**BEFORE THE PUBLIC UTILITY COMMISSION
OF OREGON**

LC 80

In the Matter of
PORTLAND GENERAL ELECTRIC,
2023 Integrated Resource Plan and
Clean Energy Plan.

**ROUND 1 COMMENTS OF
RENEWABLE NORTHWEST**

Figure 7. Capacity need comparison

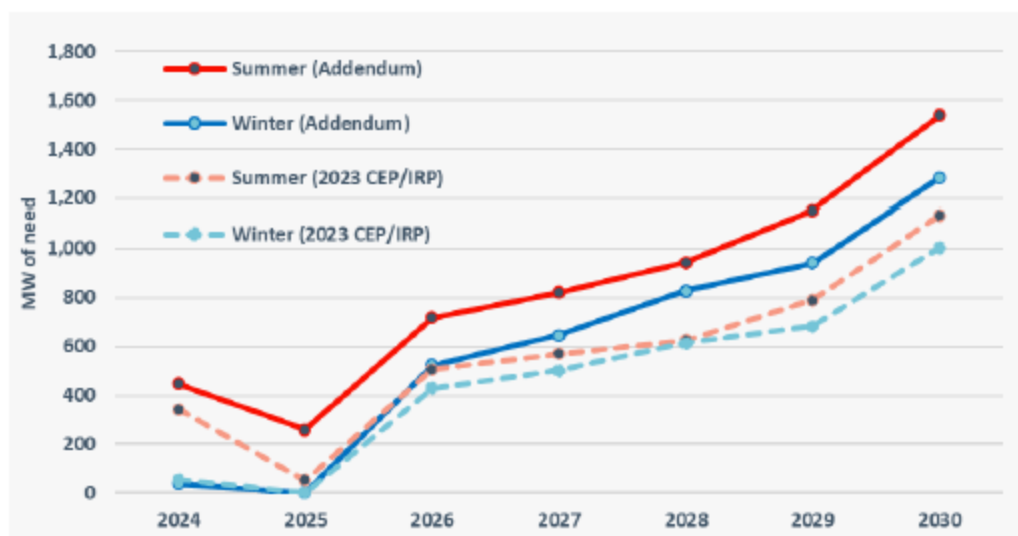
PGE provides a clear description of its seasonal capacity needs for future years in the IRP planning horizon. As a part of its Portfolio Analysis Refresh addendum, the utility updated its capacity needs and included a graphical depiction of its summer and winter capacity needs by year in Figure 7.⁹ In 2028, PGE has a need for 944 MW and 827 MW of firm capacity in the summer and winter seasons, respectively.

Figure 1

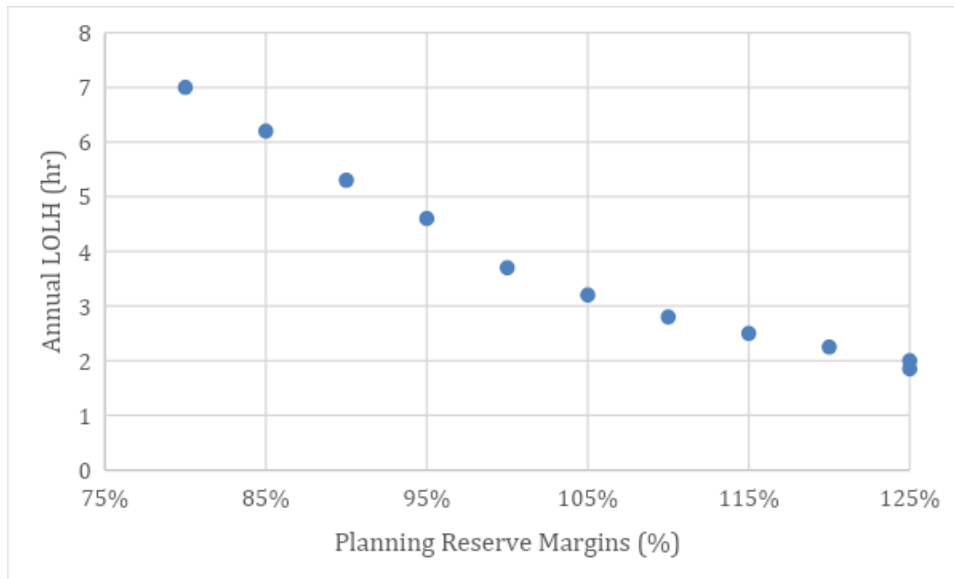
Presuming PGE continues to use LOLH as the sole driver of investment in new resources, it should not arrange Sequoia-generated outages in descending order. Rather, it should model varying amounts of a generic resource of perfect capacity to determine the amount necessary to achieve its stated reliability target. In Figure 1 below, RNW provides an illustrative example of the general relationship it would expect to see between reserve margins and reliability in a well-designed RA methodology.

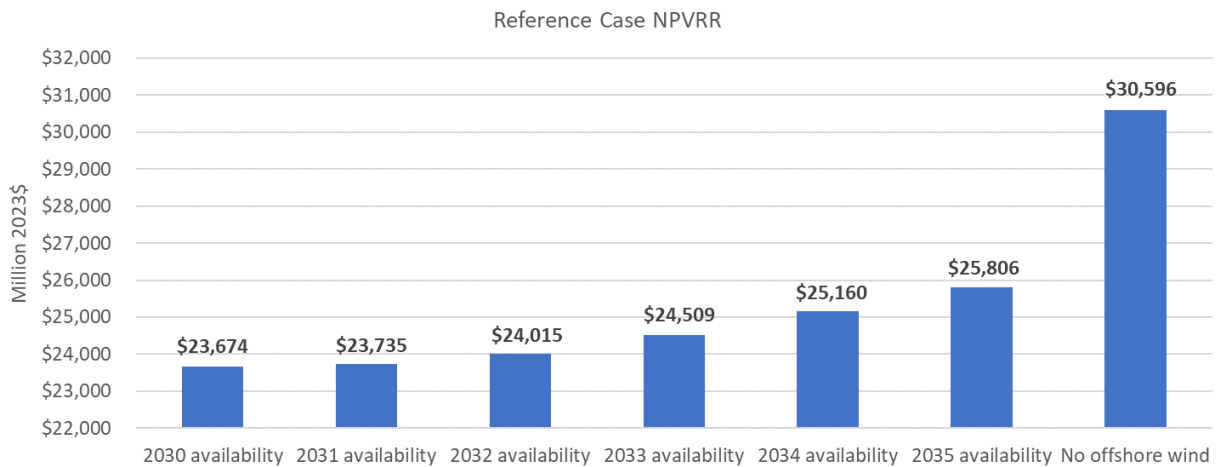
PGE's IRP analysis of offshore wind is reported in Figure 100.⁹² This figure compares offshore wind against a set of "emerging technologies" and shows that offshore wind results in the lowest cost portfolio among the different technologies that are considered. The cost of the emerging technology offshore wind portfolio is \$39 billion,⁹³ which is higher than PGE's proposed preferred portfolio, at \$37 billion. A cursory review of this result therefore suggests that, while offshore wind is the most economic "emerging technology" resource, it is less economic than the resource in the preferred portfolio. However, this conclusion is incorrect because PGE's emerging technology portfolios did not allow for the selection of transmission assets.
